STAFF ANALYSIS

Case No.: SLUP-18-22039/ 2018-1592 **Agenda #:** N.4

Request: To request a Special Land Use Permit to allow a Wendy’s restaurant with a drive-through lane in the C-1 (Local Commercial) District in accordance with Section 27-4.1 Use Table and Section 27-4.2.23 of the DeKalb County Code.

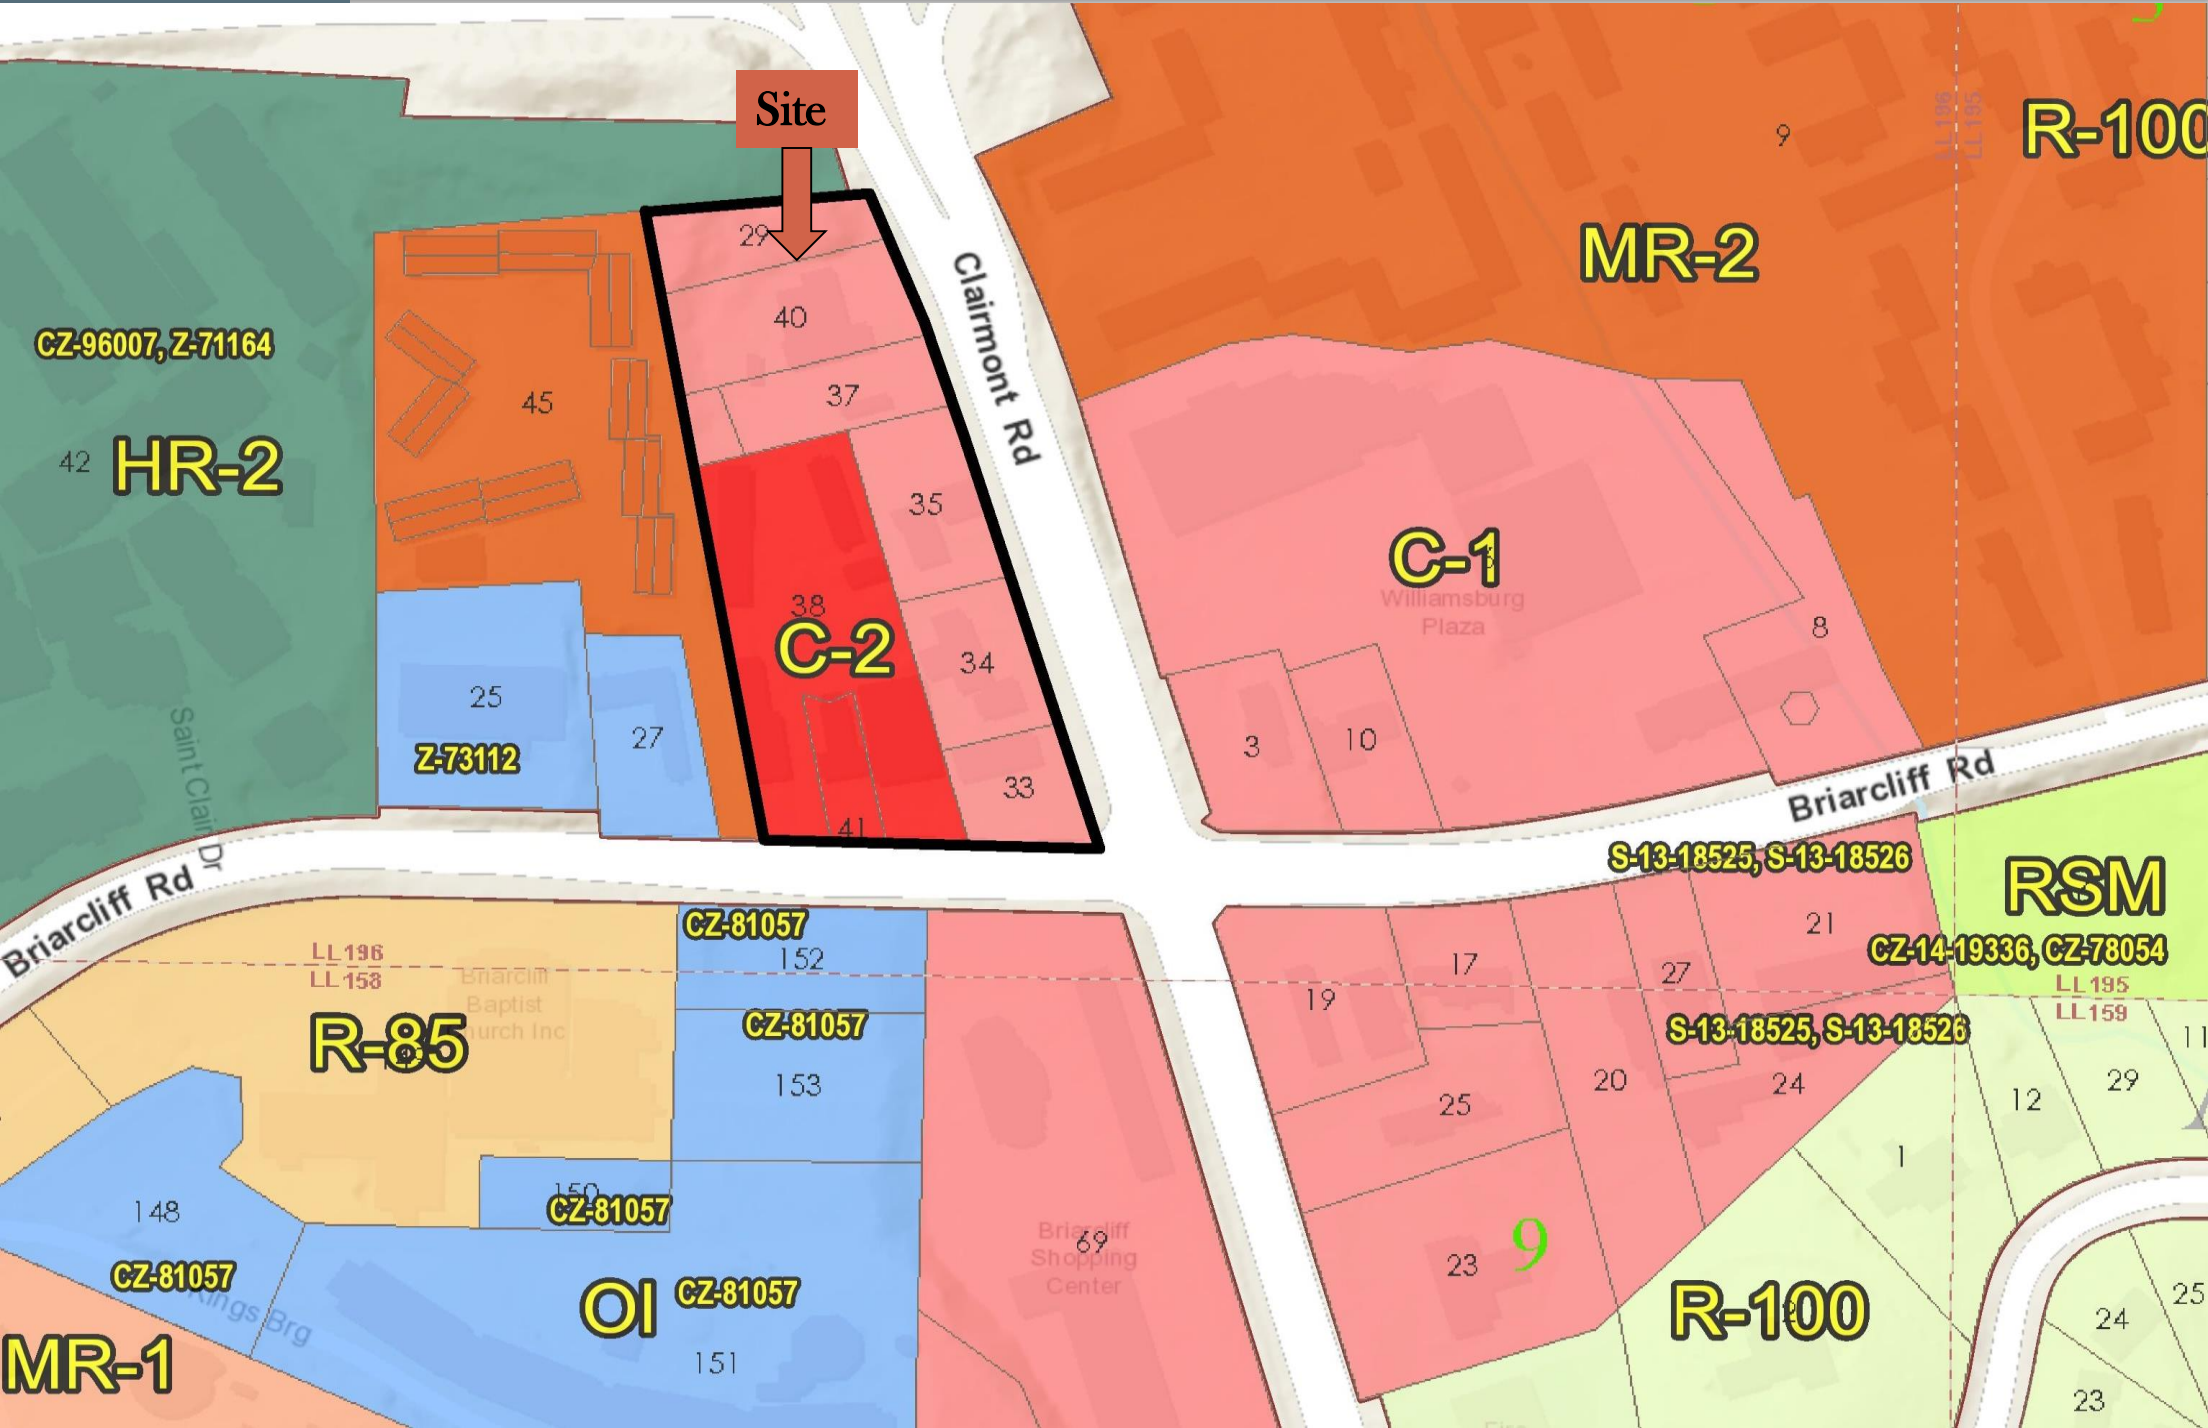
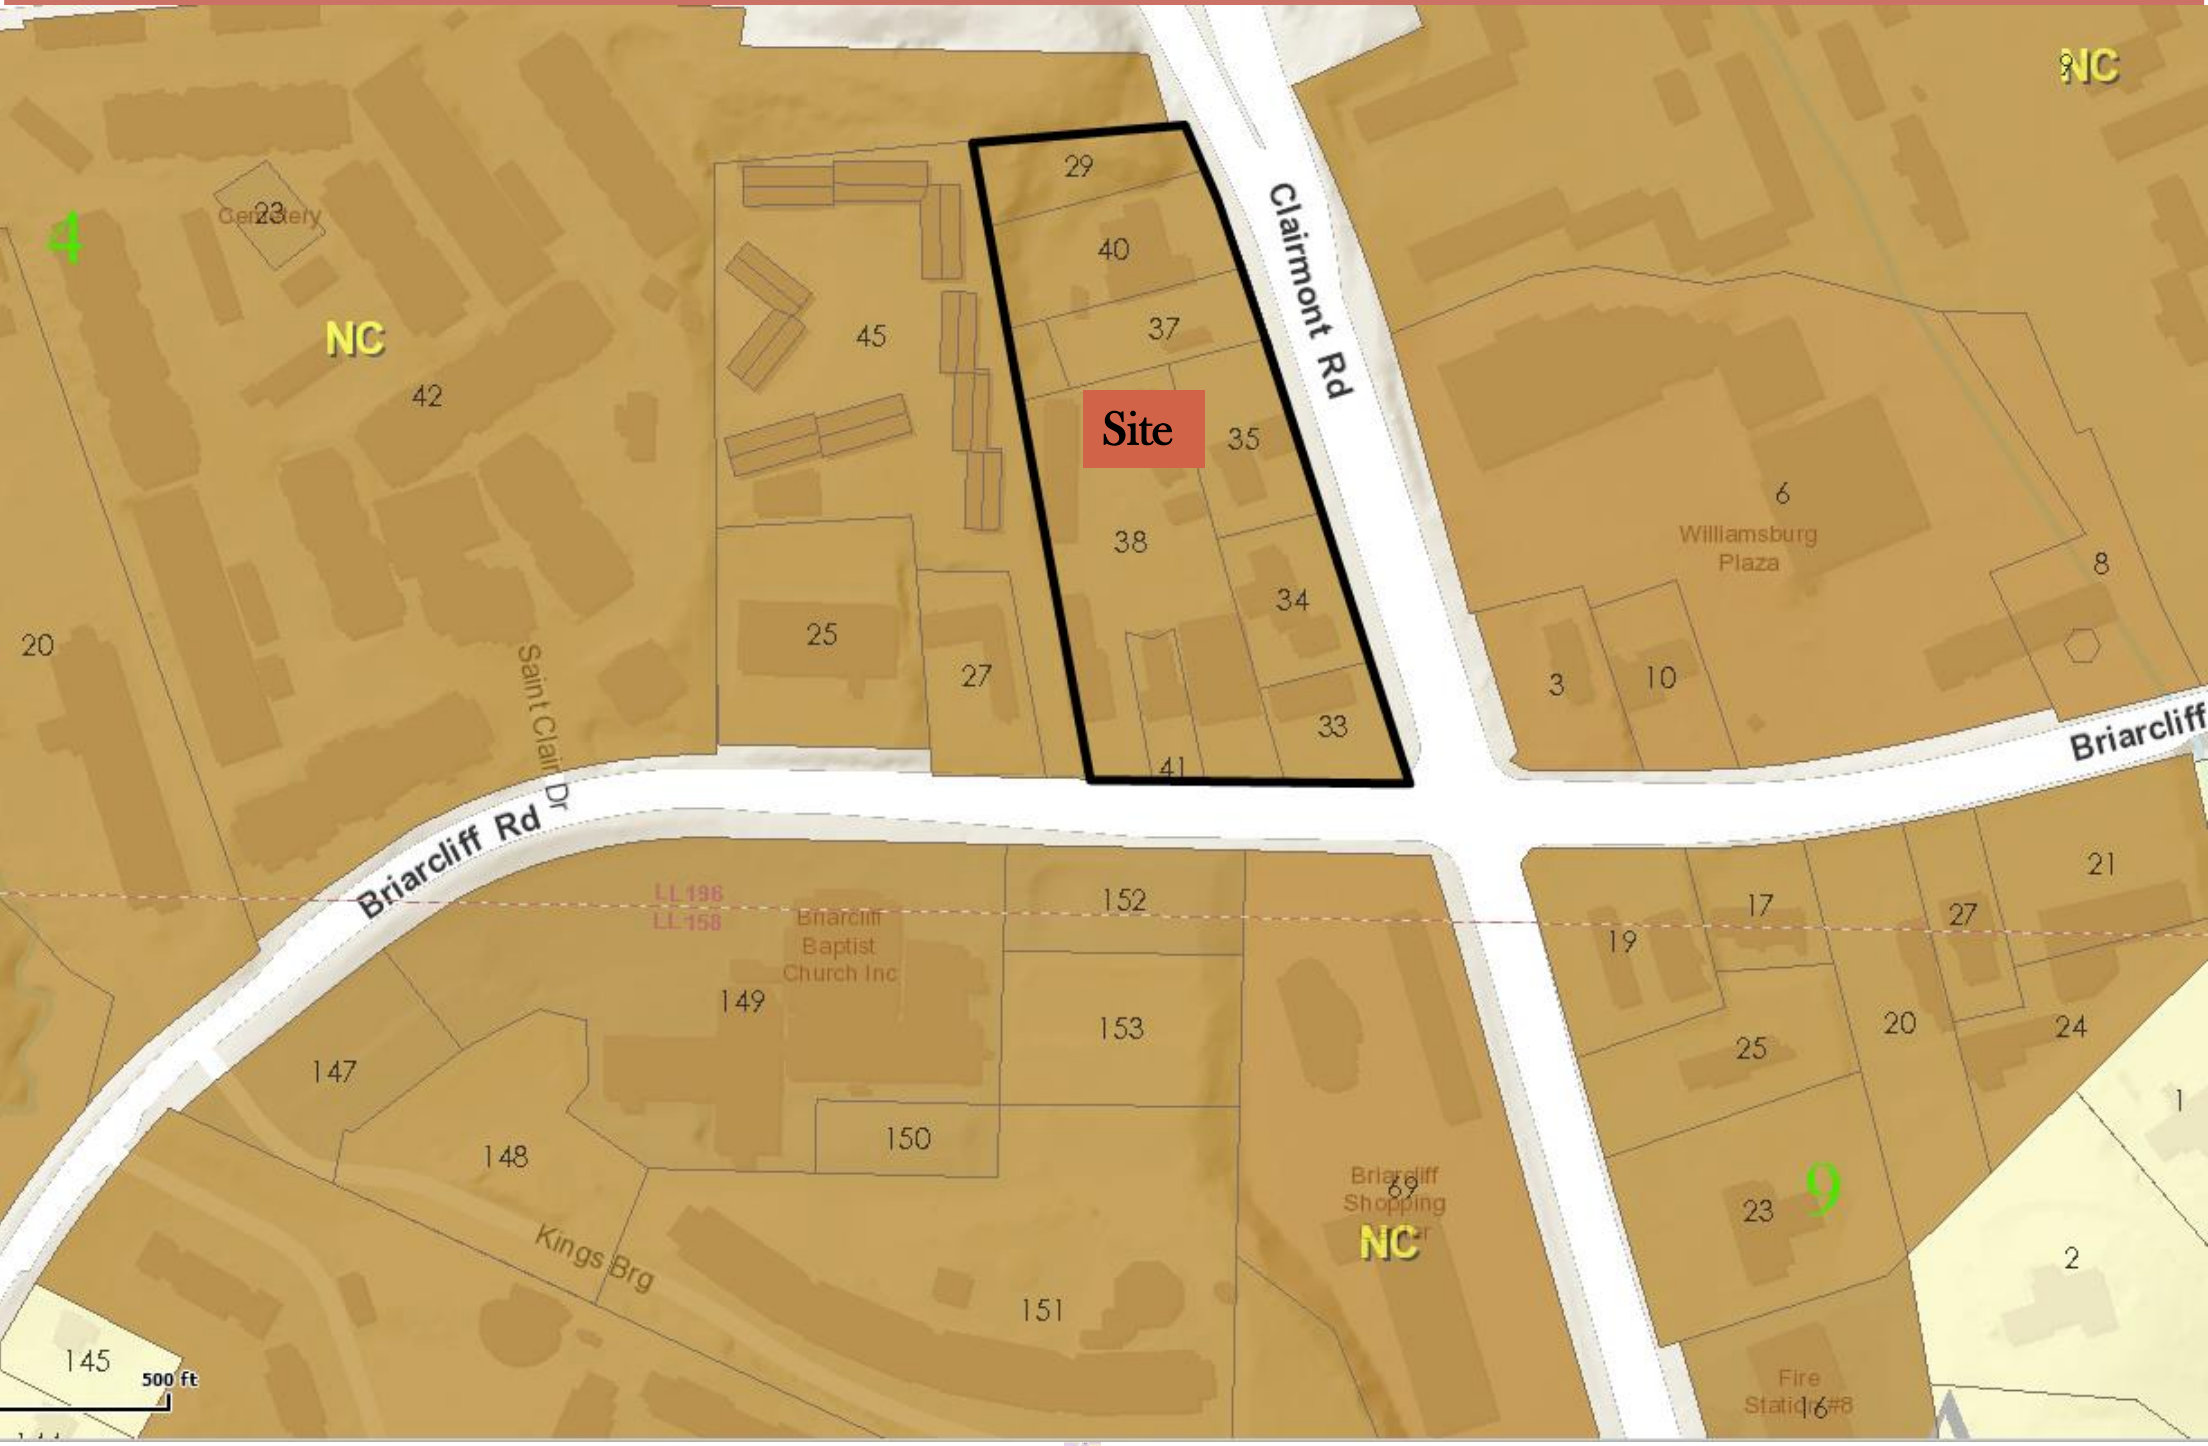
The site proposes 31 on-site parking spaces for Wendy's customers. A 10-foot wide landscape strip is depicted along the Clairmont Road property frontage. Staff notes the submitted site plan depicts an encroachment into the required transitional buffers adjacent to residential zoned properties. Also, the Landscape Plan exhibit fails to show planting requirements for the transitional buffer. A pedestrian connection from the property to the sidewalk is shown along Clairmont Road which Staff shall include in the recommended conditions. The SLUP request to allow a drive-through restaurant on the site is compatible with other commercial uses in the area. At the northeast intersection of Briarcliff Road and Clairmont Road is a Popeye's restaurant with a drive-through lane.

PARKING LOT LANDSCAPING Article 5.4.4.D	10% total parking lot in landscape space. 1 tree per 8 parking spaces. 1 tree required.	None shown on site plan.	Site must show compliance during permitting process.

Speaker box from proposed drive-through is 60 feet from residential zoned property.

Per the submitted site plan, speaker boxes are oriented towards the proposed RaceTrac convenience store building on Tract 1 of the overall development.

Site plan depicts a bypass lane with a width of 18 feet in compliance with above standard.

The submitted site plan depicts an encroachment (access drive) within required transitional buffer along adjacent residential zoned property lines.

1. A restaurant with a drive-through lane as depicted on the site plan stamped received by the Department of Planning and Sustainability on January 30, 2018. Said site plan is conceptual and is subject to compliance to C-1 (Local Commercial) development standards unless variances are obtained from appropriate regulatory authorities.

3. Provide inter-parcel access to all adjacent parcels subject to the approval of the Department of Public Works, Transportation Division.
4. Provide a pedestrian connection from the Wendy's restaurant to the public sidewalk.

7. Provide parking lot lighting on site.
8. The approval of this SLUP application by the Board of Commissioners has no bearing on the requirements for other regulatory approvals under the Zoning Board of Appeals, or other entity.
